HOWARD COUNTY HISTORIC PRESERVATION COMMISSION
ELlicott CITY HISTORIC DISTRICT ■ LAWYERS HILL HISTORIC DISTRICT
3430 Court House Drive ■ Ellicott City, Maryland 21043

June Minutes

Thursday, June 4, 2020; 7:00 p.m.

Figure 1 - Corrected view of shed dormer to reflect siding instead of roofing shingles.

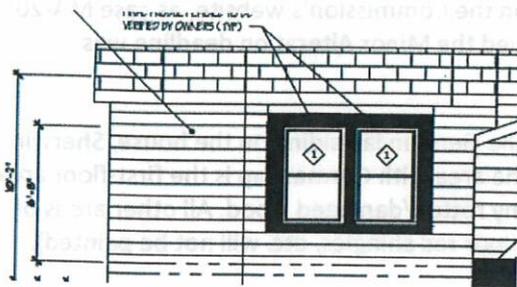
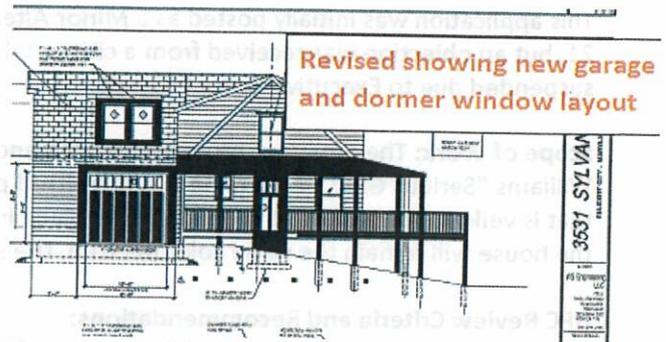
The elevation incorrectly shows roofing shingles on the revised shed dormer, instead of siding. The applicant noted that was to remain siding and not become roofing shingles and submitted an edited view of this elevation to correctly show siding.

Figure 6 - Existing garage

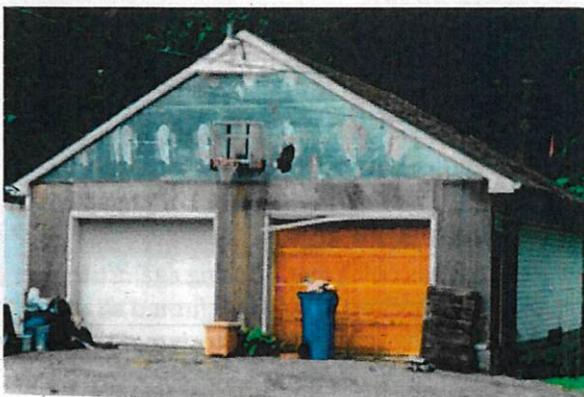
Ms. Zoren said in Figure 6 of the staff report, there was an existing garage with a basketball hoop, and noted the siding on the garage in Figure 6 did not have vinyl siding. Ms. Zoren asked if Mr. Engebretsen was proposing to add vertical wood siding on that garage as well.

Figure 13 - Rear metal door and proposed wider awning.

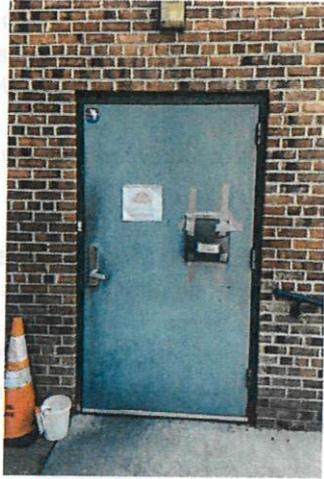
Ms. Zoren noted there may be a conflict on the back door location where the awning is to be added. Currently there is a light in that location, and it may need to be replaced. Ms. Zoren said if the applicant had to move the light, they would need to come back to the Commission for approval of the light relocation. Ms. Zoren reminded the applicant install the awnings and light in the mortar, not brick.

Figure 16 - Location of T-104, T-94, T-95 and T-97

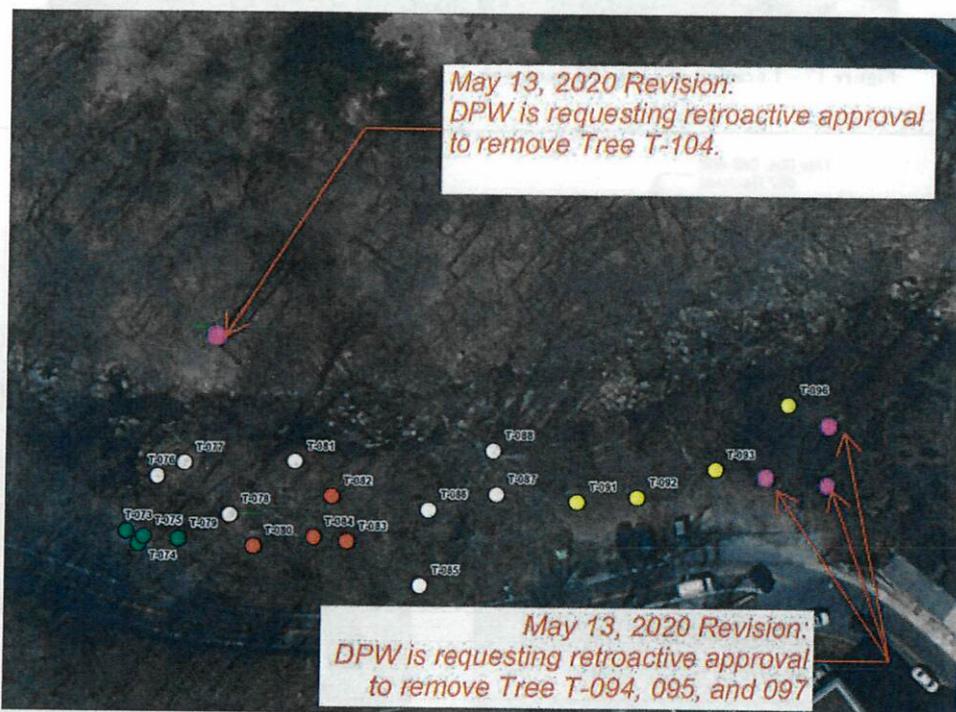
Mr. DeLuca said that was true for three trees, but the request is for two different issues that DPW wanted to handle together. The project required that they replace a water line that ran perpendicular to the stream. There were two trees on the original plan (HPC-19-72) that were to be removed, but the exhibits in HPC-19-72 accidentally omitted those trees. The original request was the approval for the removal of 28 trees, but two of the trees were missing from the request for approval. DPW was not aware of the omission until all the trees were counted against the exhibit and DPW realized one tree was missed and they needed to come back for approval. He said it was Tree 103 or 104 that was missed on the original submission (the application states it was Tree 104).

Figure 18 - Area of slope failure and T-94, T-95 and T-97 removal, picture from application

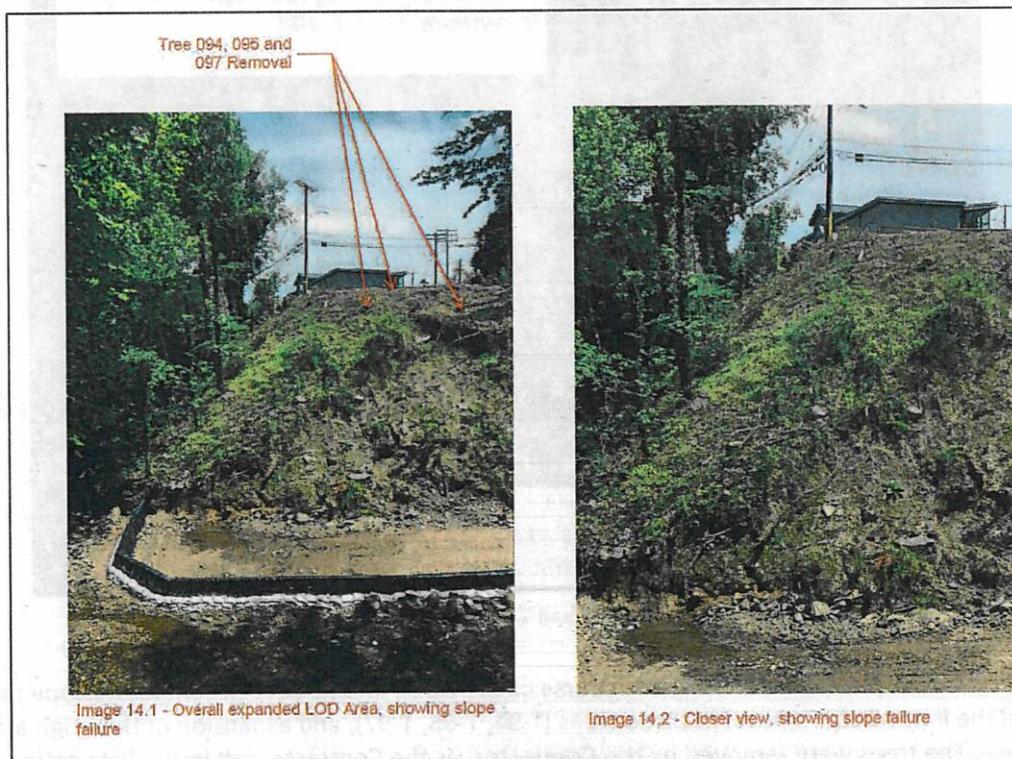
Mr. DeLuca said the second issue was found on May 13. DPW found out there was an active slope failure and the contractor could not construct the wall the way they wanted to. Mr. DeLuca referred to supplemental information, the left-hand side photo shows area of slope failure. The plan was to work from the bottom of the slope and drop it back, make it flatter, to put the caissons in the base. One of the ways to make it safe was to cut a bench (shown on the exhibit as a yellow rectangle going across the slope). DPW staff noticed trees were removed and saw three trees removed that were about 12 inches. DPW amended the May 13 application to include the three trees that were removed. Mr. DeLuca said the contractors was afraid the trees would fall down and any equipment put down there would be

Mr. Shad asked if the hill was starting to fail before the trees were removed. Mr. DeLuca said the photo shows a new slope failure, the slope is very loose. He explained that once the failure started, it started to work its way to the top. Mr. Shad asked if Mr. DeLuca thought this was in the process before the trees were removed. Mr. DeLuca said yes. Mr. DeLuca also explained that at the May 2019 meeting, DPW didn't have a tree plan to show. Mr. DeLuca submitted a supplemental tree plan, to show what trees are being planted.

Figure 20 - Historic house in the Tudor Revival style at 3958 Old Columbia Pike

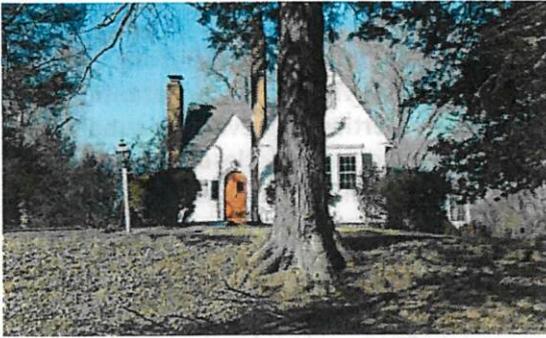
The new homes are shown in a “modern craftsman style,” which is not compatible with the existing historic house at 3958 Old Columbia Pike. The house at 3958 was constructed in the Tudor Revival style. The examples provided of the new homes will be significantly larger than the existing historic house, share no similar architectural features, and impact the viewshed and setting of the historic structures.

Mr. Shad agreed with the other Commissioners comments about the styles of the houses and would like to see something more compatible with the current houses. The presented plan looks like stone mansions compared to what is presently there. Mr. Shad said he had an issue with the density and thought it would be more appropriate to have three lots that would be larger in size than to stack five houses in the development.
